Executive Greentex Limited

9th and 23rd February 2021

Building Information

Observations

Roof layout

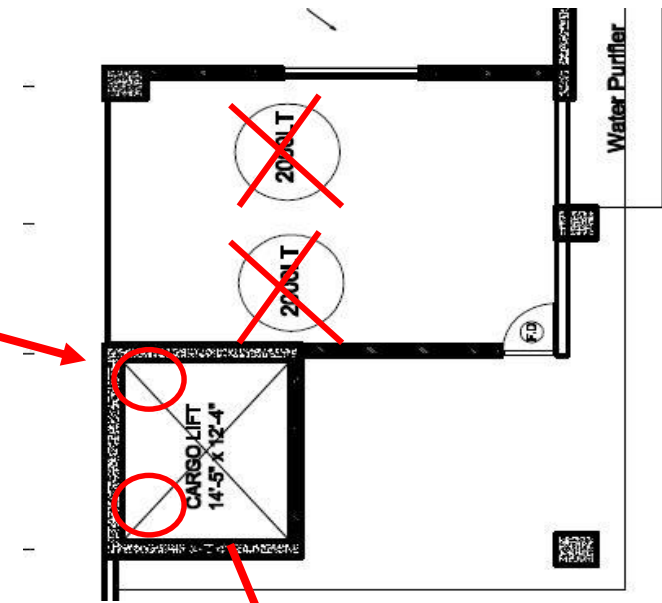
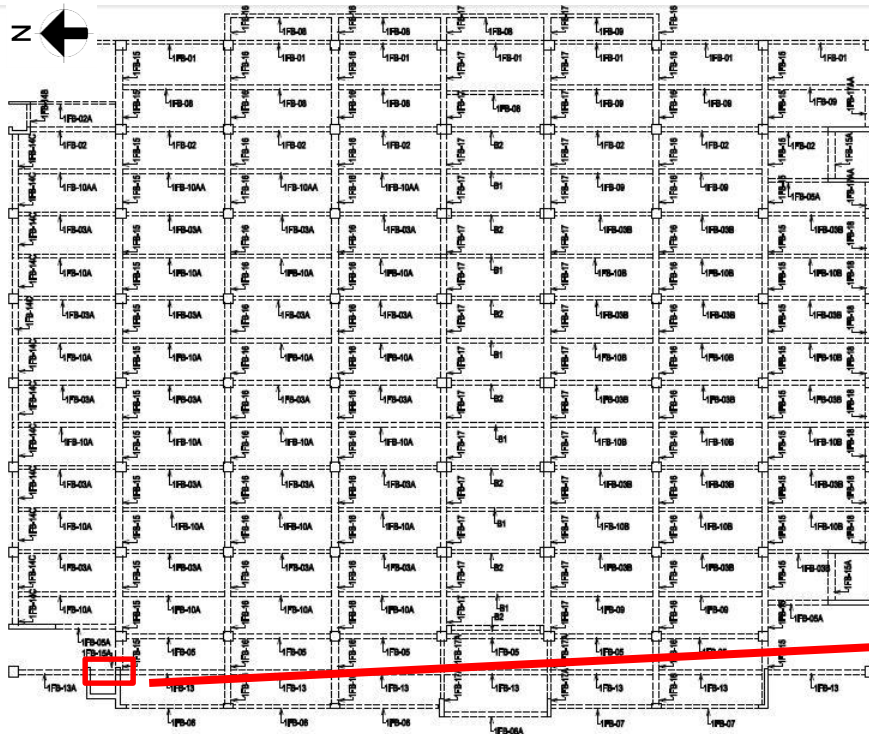
Position of plastic water tank didn't match with roof layout. Two plastic water tank each of 5000 liter were found resting on lift machine room but shown in drawing on staircase. Factory engineer is required to survey the whole structure and update the as-built drawing as per on-site condition in accordance with section 1.9.1.2 (BNBC Part-6) . Also, check the adequacy of the slab of the lift machine room.

Water tank position didn't match

2 Water tanks (capacity-5000 liter) are rested on lift room

Typical beam layout

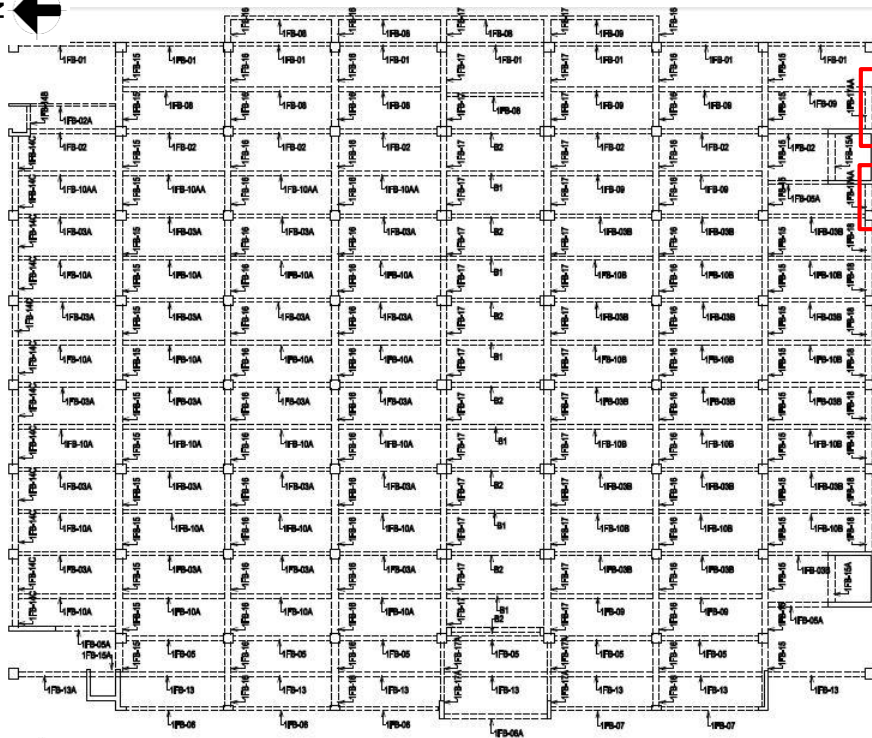
At roof level (north -west stair) shear wall constructed over beam but doesn't continue at lower level. Factory engineer is required to survey the whole structure and update the as-built drawing as per on-site condition in accordance with section 1.9.1.2 (BNBC Part-6).

At conveyor area extra beam (375mm W X 525mm d/s) was found at First to top floor but not shown in provided drawing. Also, at upper floor the beam layout of that area was found different with as-built condition. Factory engineer is required to survey the whole structure and update the as-built drawing as per on-site condition in accordance with section 1.9.1.2 (BNBC Part-6).

Width of the beam measured 375mm W

Depth of the beam measured 525mm d/s

Typical beam layout

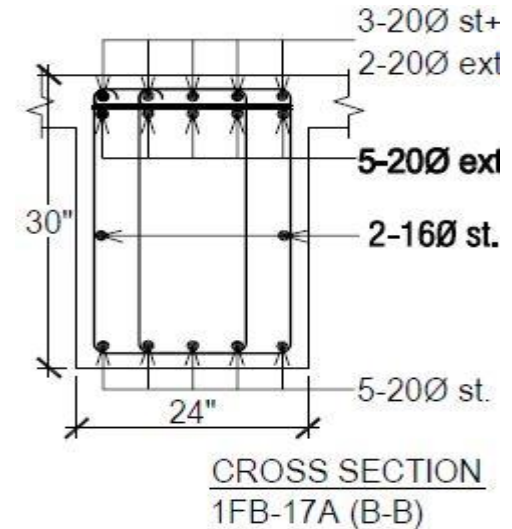
Width of the highlighted beam was found 375mm instead of 600 mm. Factory engineer is required to survey the whole structure and update the as-built drawing as per on-site condition in accordance with section 1.9.1.2 (BNBC Part-6).

Width of the beam measured 375mm W

Depth of the beam shown 600 mm

Roof layout

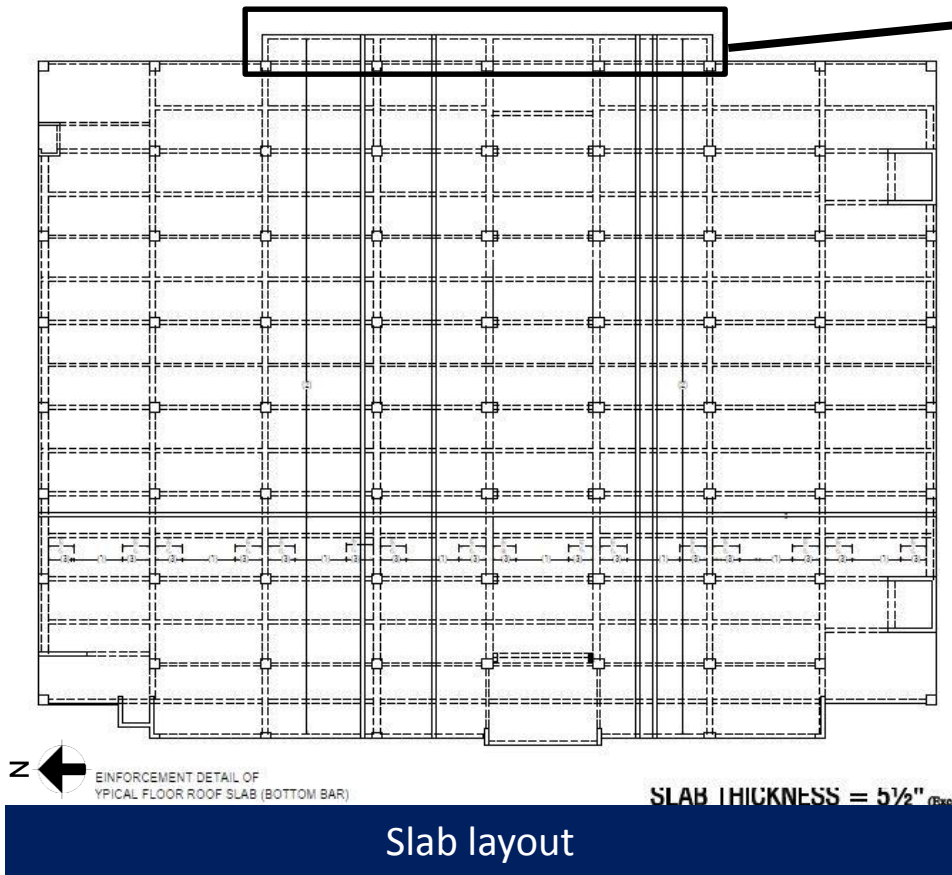
No detail of beam/slab was shown in provided drawing for the staircase and lift machine room at roof level. Factory engineer is required to survey the whole structure and update the as-built drawing as per on-site condition in accordance with section 1.9.1.2 (BNBC Part-6) . Also, update the Design report in accordance with 1.9.1.1 (BNBC Part-6).

Stair room at south west side

Stair and lift area at south east corner

Protection against vehicle impact appears to be fragile

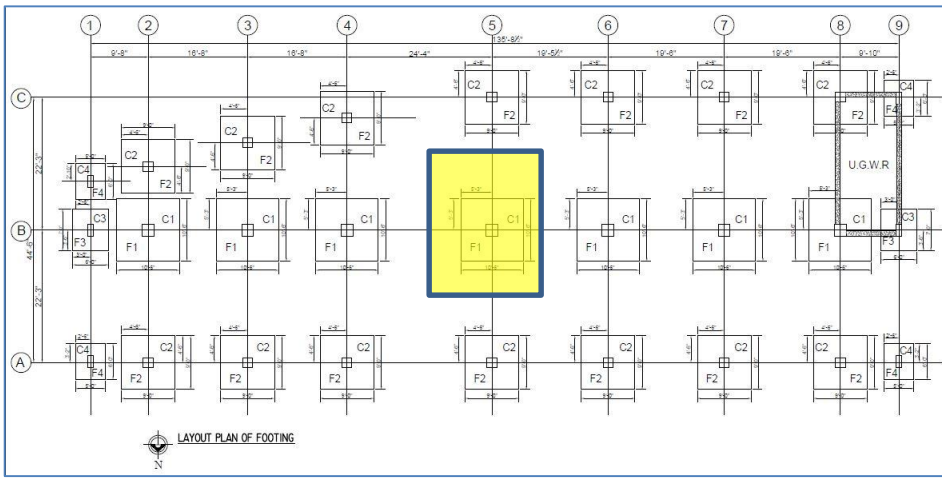
Barrier provided with thin member

Barrier provided with thin member

Barrier provided for some columns to prevent the vehicle impact, but the members installed as barrier appears to be thin and fragile. Factory is required to provide the barrier to prevent vehicle impact with proper engineering calculation against possible vehicle load.

Footing Layout Plan.

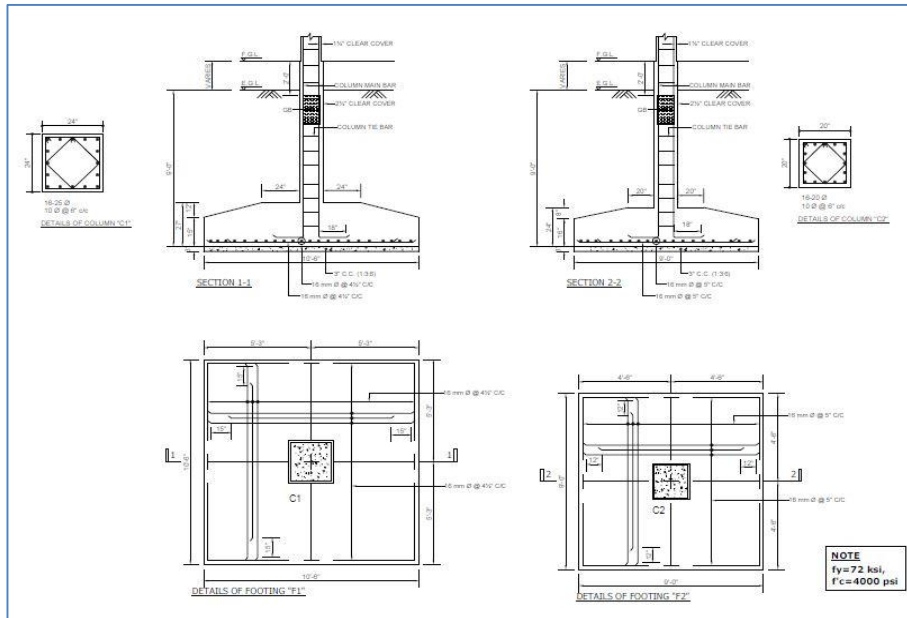
Cursory calculation indicates that stress in foundation exceeds normal design limit in the highlighted area considering the prepared live load plan (11.9 KPa for typical floor and roof). Factory engineer is required to review the adequacy of footings and comply with BNBC as a part of Engineering Assessment (EA). Also, maintain live load below 5 KPa at all floor areas including roof until the Engineering Assessment (EA) is finalized.

Marked footings are shown as overstress in existing Design Report

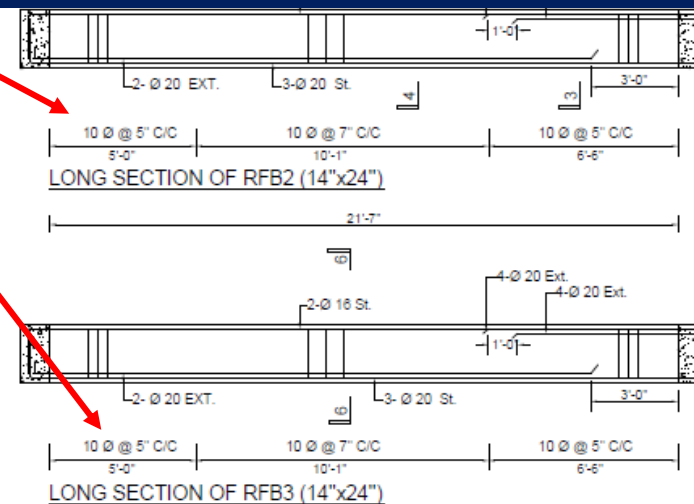
In existing Design Report, some footings are demonstrated as overstressed considering live load as 11.9 kPa but no remediation plan is proposed for those overstressed footings. Factory engineer is required to propose remediation plan as a part of the Engineering Assessment (EA) and implement accordingly.

Roof beam layout

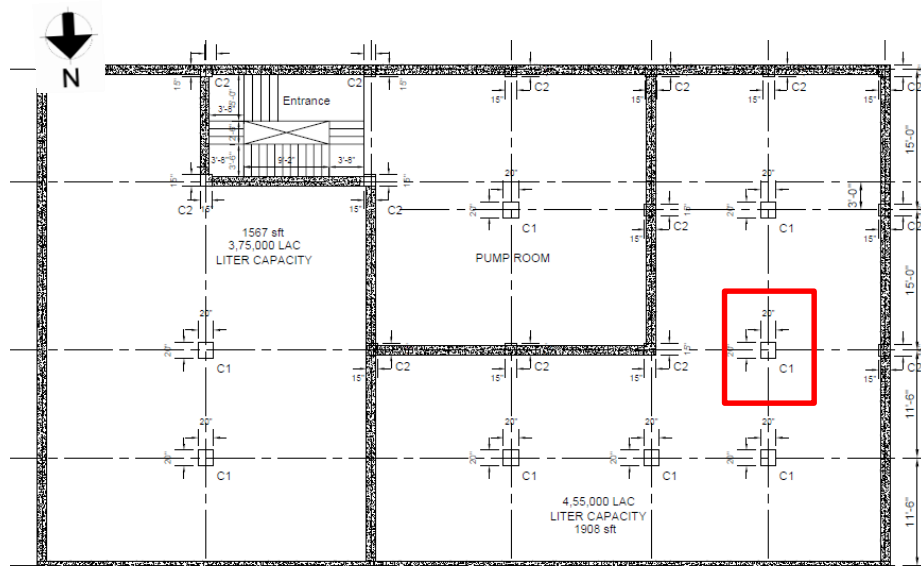
Dimension of same beam is shown differently in beam layout and beam section. For example, width of RFB-2 shown in layout but in section dimension shown for the same beam as 350mm. However, dimension of all beams was found as per section of the beam. Factory engineer is required to survey the whole structure and update the as-built drawing as per on-site condition in accordance with section 1.9.1.2 (BNBC Part-6).

Column layout

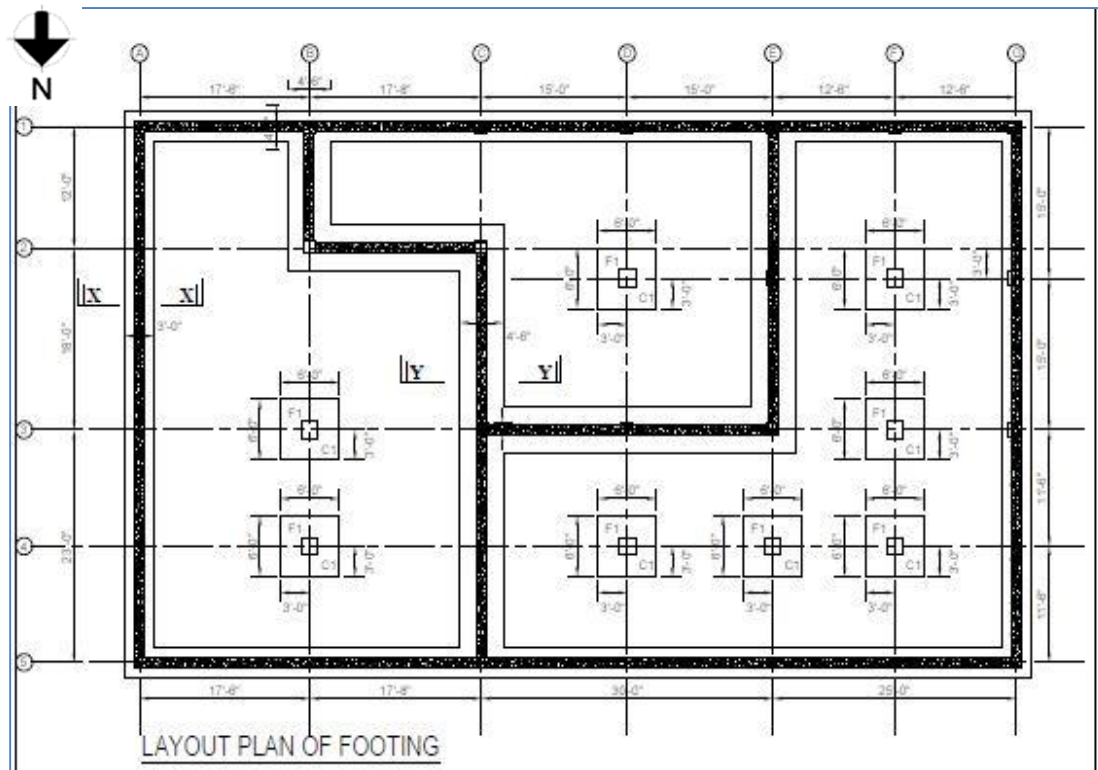
Dimension shown 500mmX500

Column layout is not produced separately for Ground floor. Dimension column C-1 at grid F-3 was found 375mmX375mm instead of 500mmX500mm (shown in provided drawing). Factory engineer is required to survey the whole structure and update the as-built drawing as per on-site condition in accordance with section 1.9.1.2 (BNBC Part-6). Also, review column the stress in accordance with 1.9.1.1 (BNBC Part-6).

Dimension found 375mmX375mm

Foundation layout (Isolated footing)

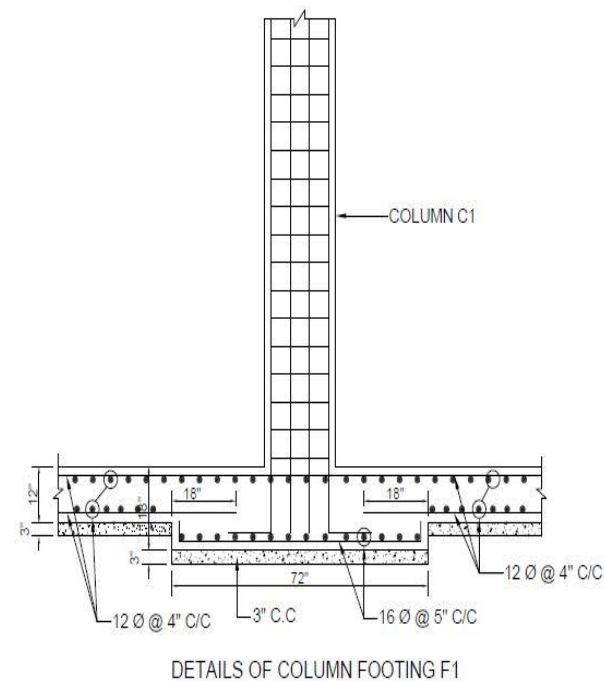
Foundation depth from Existing Ground Level (EGL) not shown in provided drawing. Factory engineer is required to survey the whole structure and update the as-built drawing as per on-site condition in accordance with section 1.9.1.2 (BNBC Part-6).

Foundation depth is not mentioned in drawing
